**SUBJECT: ARKANSAS NUCLEAR ONE – NRC INSPECTION REPORT 05000313/2014005  
and 05000368/2014005**

Report: 05000313/2014005; 05000368/2014005

Facility: Arkansas Nuclear One, Units 1 and 2

IR 05000313/2014005; 05000368/2014005; 10/01/2014 - 12/31/2014; Arkansas Nuclear One, Units 1 and 2, Integrated Inspection Report; Equipment Alignment, Maintenance Rule, Exercise Evaluation, Problem Identification and Resolution.

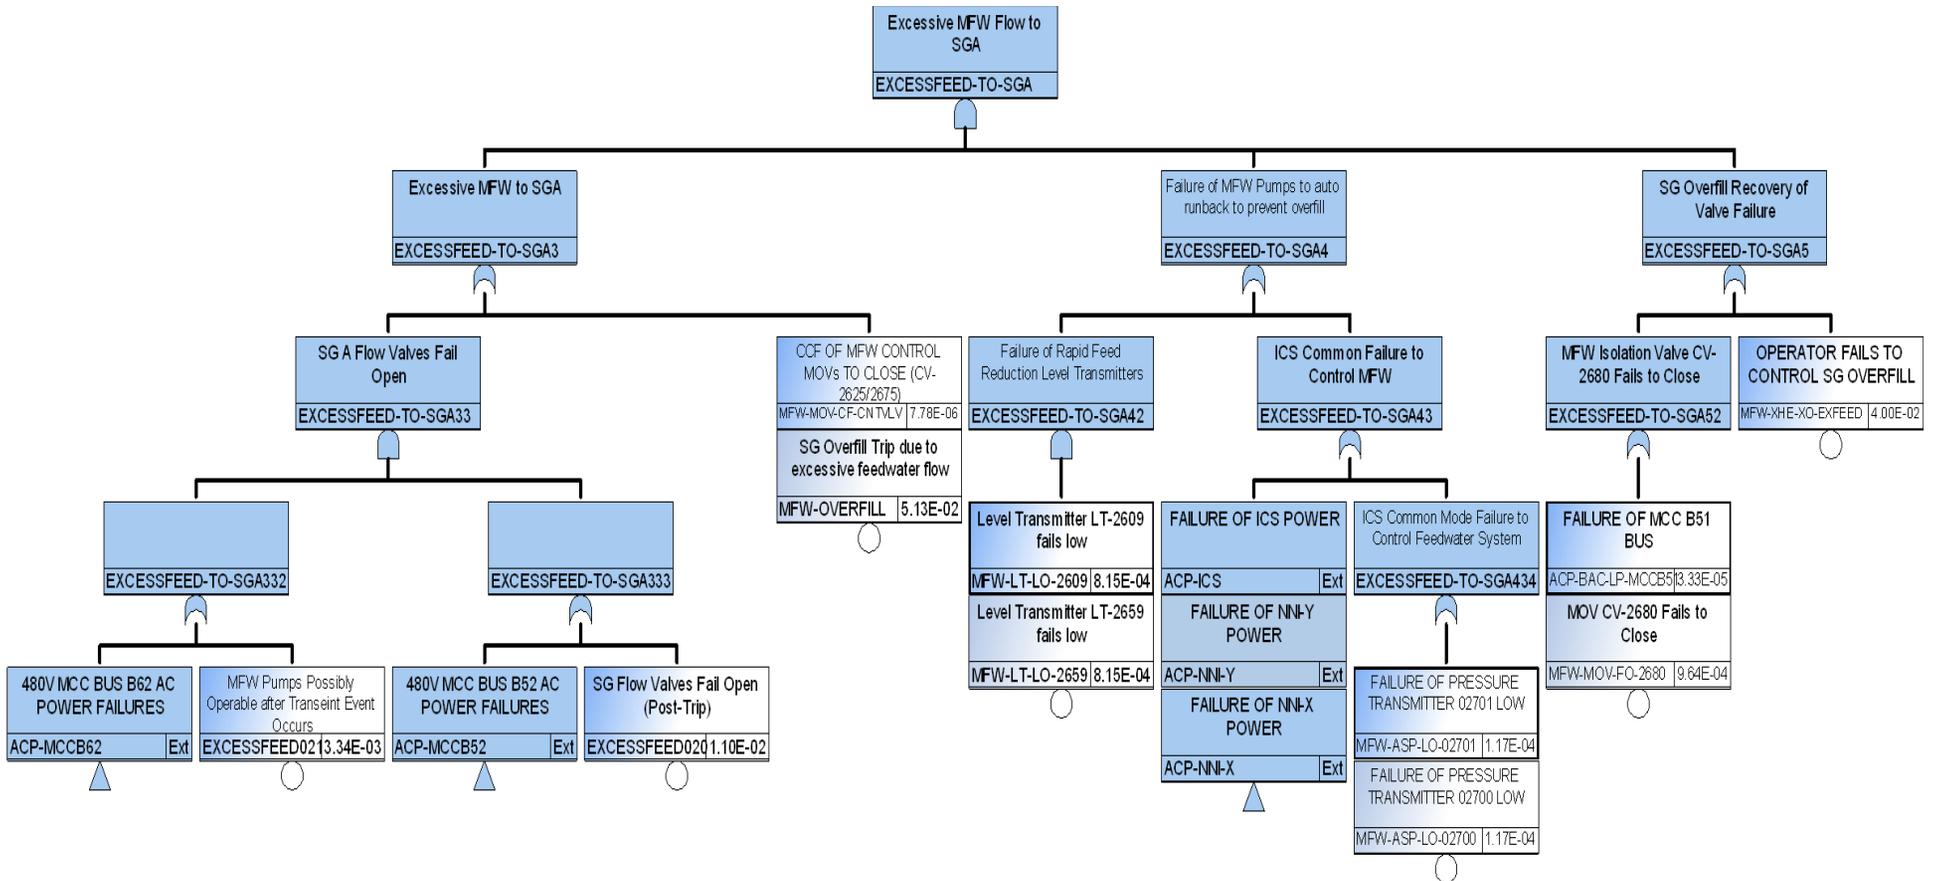
The licensee failed to provide minimum flow protection for the Unit 1 auxiliary feedwater (AFW) pump in emergency and abnormal operating procedures in accordance with the emergency operating procedure writer's guide.

Valve FW-1, the AFW pump's minimum flow isolation, is normally closed for thermal efficiency. It is a manually operated valve. All affected emergency and abnormal operating procedures direct starting the pump without opening the valve. All affected procedures also start the pump without a forward flowpath, with varying times to establish a flowpath. All times are inadequate due to the short time to pump damage.
